**AGENDA  
PLANNING AND ZONING COMMISSION  
JANUARY 21, 2020**

**TO:** Planning and Zoning Commission  
**FROM:** Jonathan Beckham, Planner  
**DATE:** January 21, 2020  
**SUBJECT:** **Regular Hearing: Final Plat of Thrive Nature Preserve Addition; on 21.511 Acres out of the H. Turner Survey, Abstract Number 1249; Zoned Agricultural Open Space District (AO); Located on the Southeast Corner of South Valley Parkway and West Corporate Drive, a Portion Being a Replat of a Portion of Valley Vista Estates – 3, Tract A.**

# Thrive Nature Addn Markup Summary

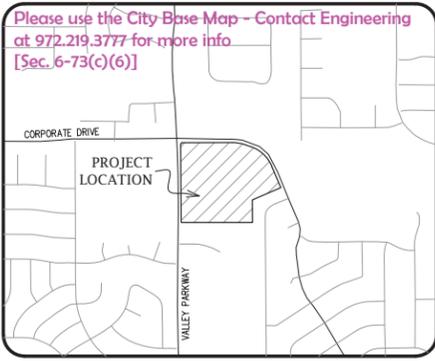
Please use the Title Block found in the Chapter 6 appendix. Include the Zoning and Survey Abstract Number [Sec. 6-73(c)(1)]
